HISTORIC AND DESIGN REVIEW COMMISSION

HDRC CASE NO: 2022-307 ADDRESS: 304 SADIE ST

TYPE OF WORK: Driveway modifications

The applicant is requesting a Certificate of Appropriateness for approval to expand the existing driveway, approach, and curb cut to 20 feet in width.

OVERLAY SITE PLAN

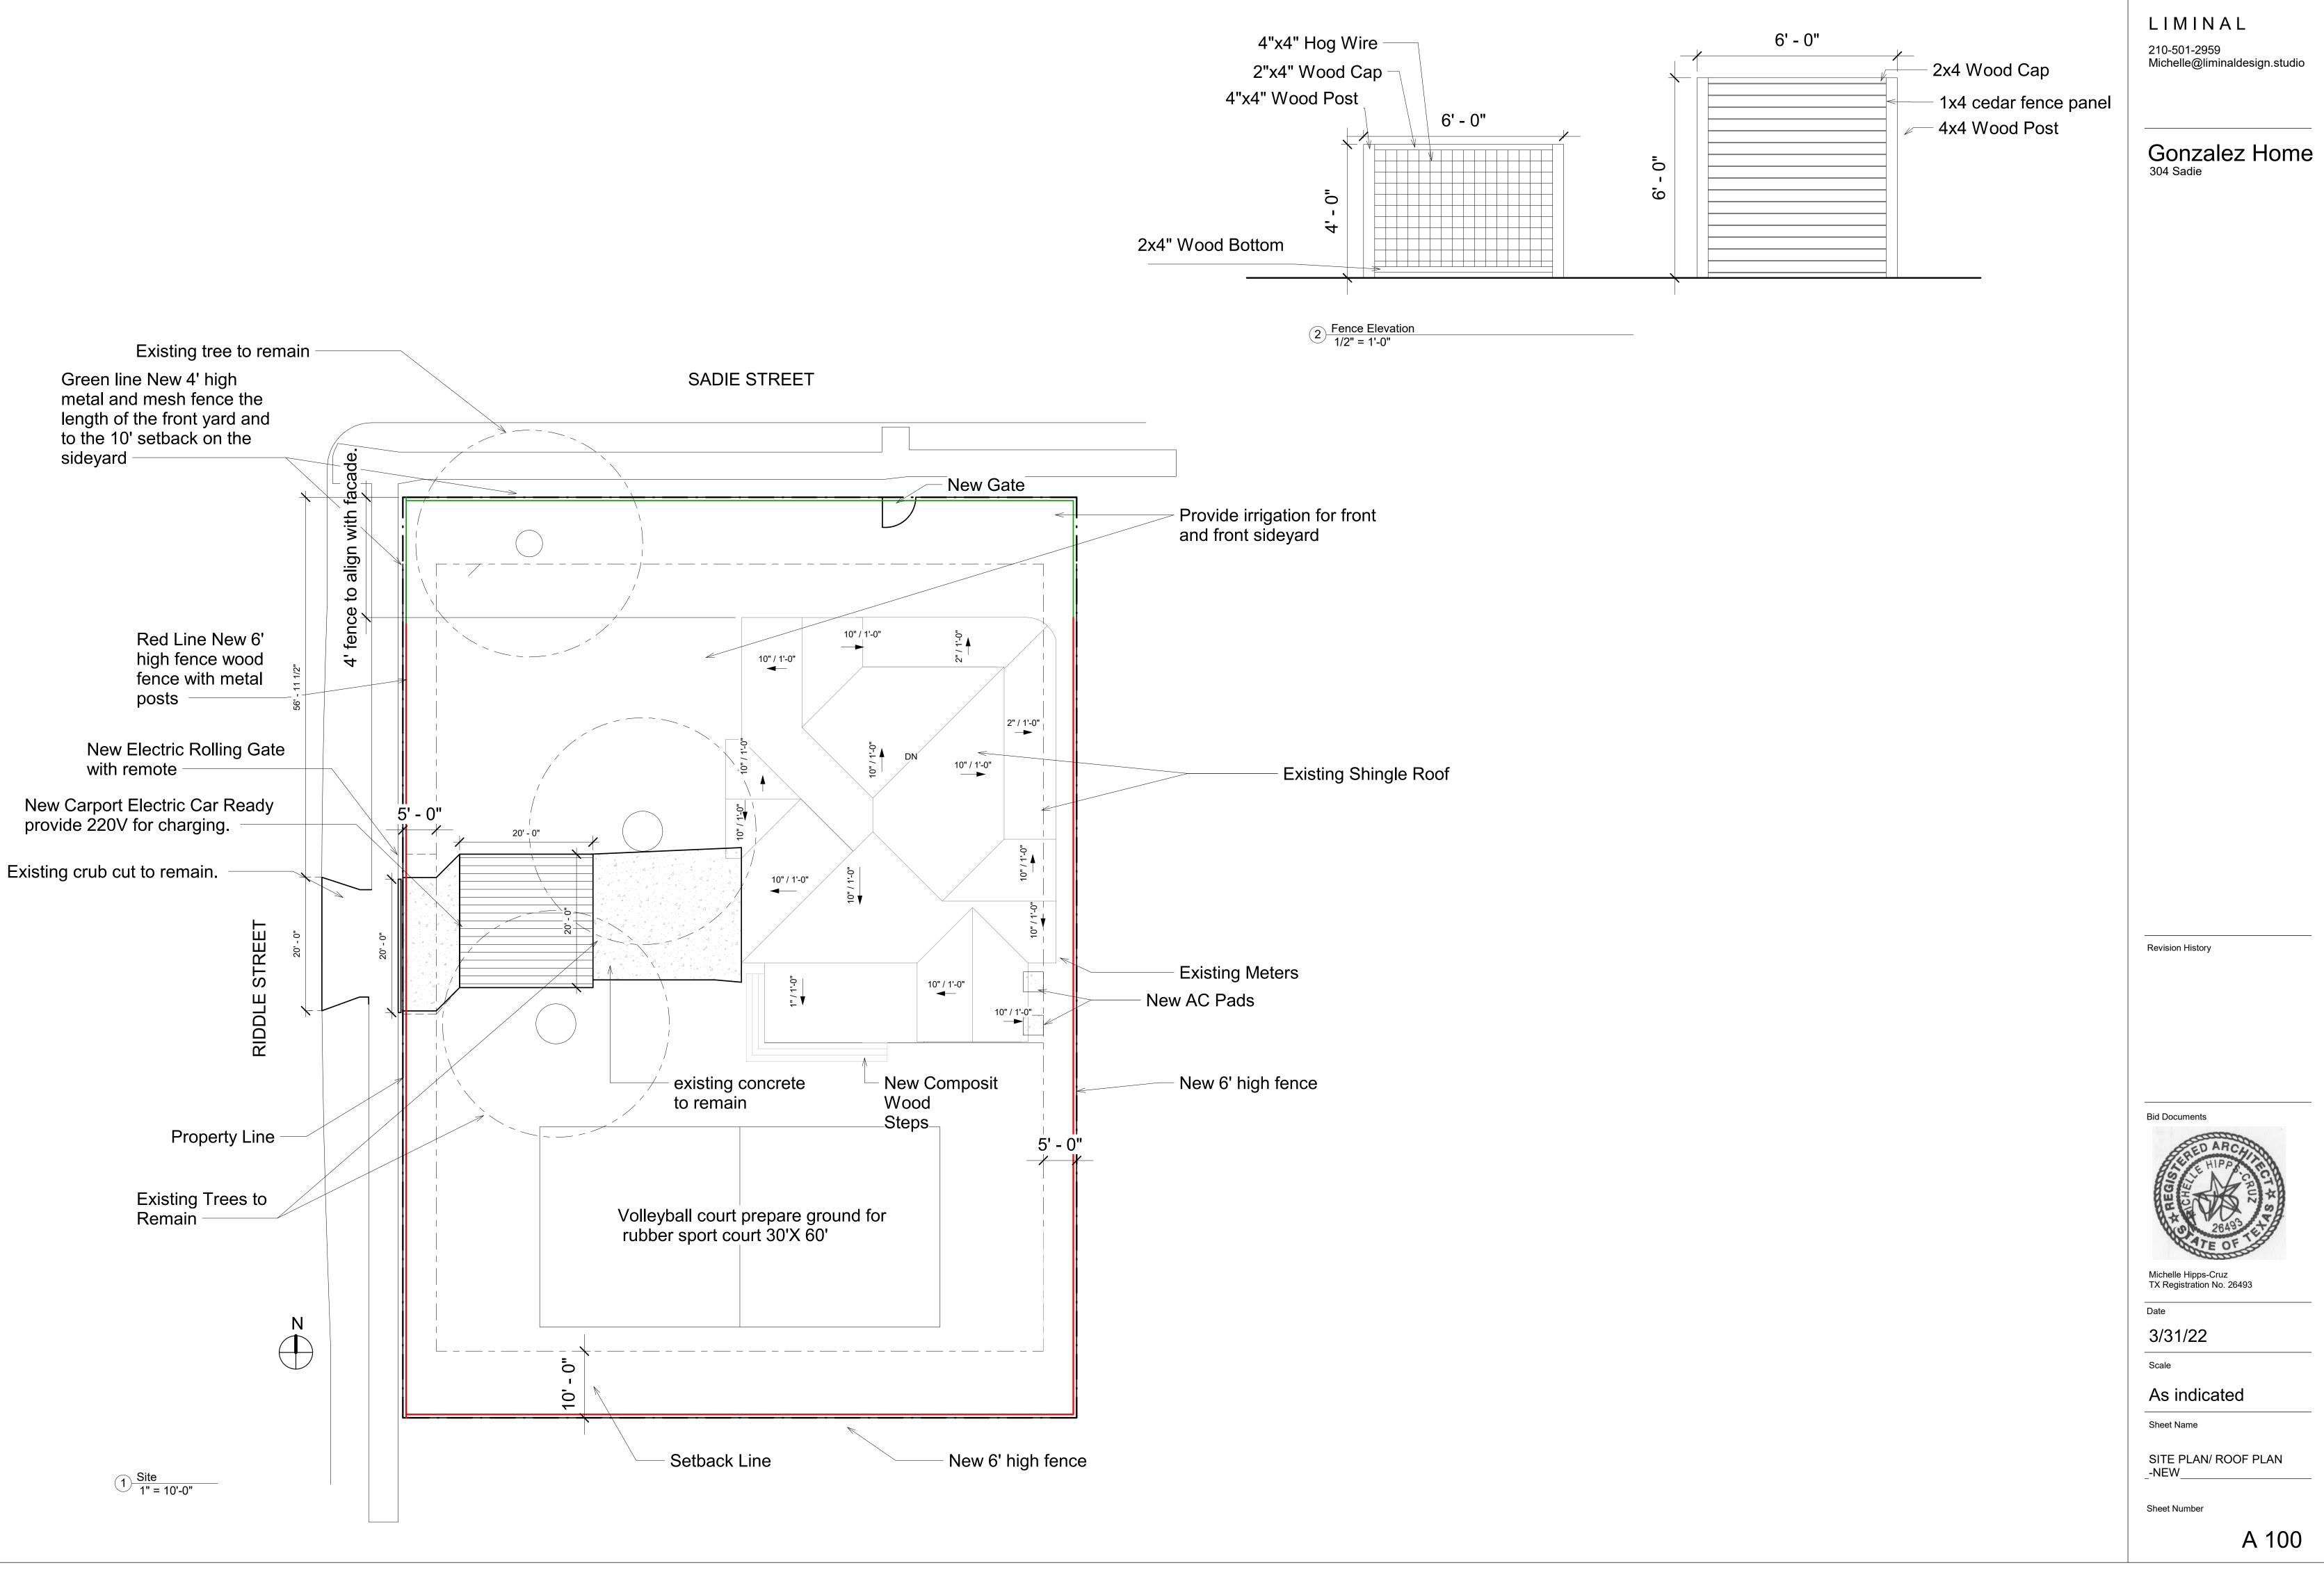
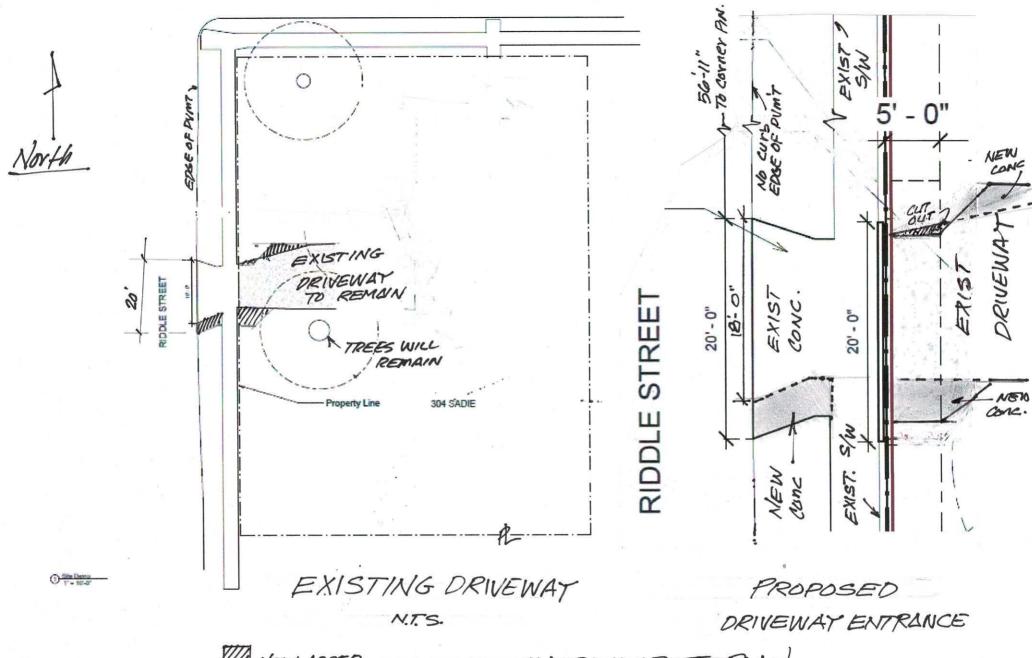
- of original curb cuts when replacing historic driveways. Staff finds the proposed curb cut modification to be inconsistent with this guideline.
- c. DRIVEWAY MODIFICATION The applicant is requesting to widen the existing driveway from a tapered configuration that widens toward the house and narrows at the street, to an angled configuration that is uniformly 20 feet in width at the approach and driveway. The existing driveway currently provides parking for two cars side by side, and has a maximum width of 20 feet. The existing driveway is wider than most driveways located in historic districts, which are typically 10 feet in width. While the existing and proposed widths are wider than recommended by the Guidelines, staff finds the proposed width to be appropriate provided that the width remains uniform throughout and that the proposed apron and curb cut feature profiles that are comparable to those found historically within the district.

- d. The current request is for modifications to the existing curb cut, driveway approach, and parking pad as confirmed by the applicant. Other scopes of work indicated in the submitted site plans are not included in the request at this time.

Staff recommends approval of items 1 and 2, with the following stipulations:

- i. that driveway modifications do not exceed the indicated measurements as proposed
- ii. that the width remains uniform throughout and that the proposed apron and curb cut feature profiles that are comparable to those found historically within the district.
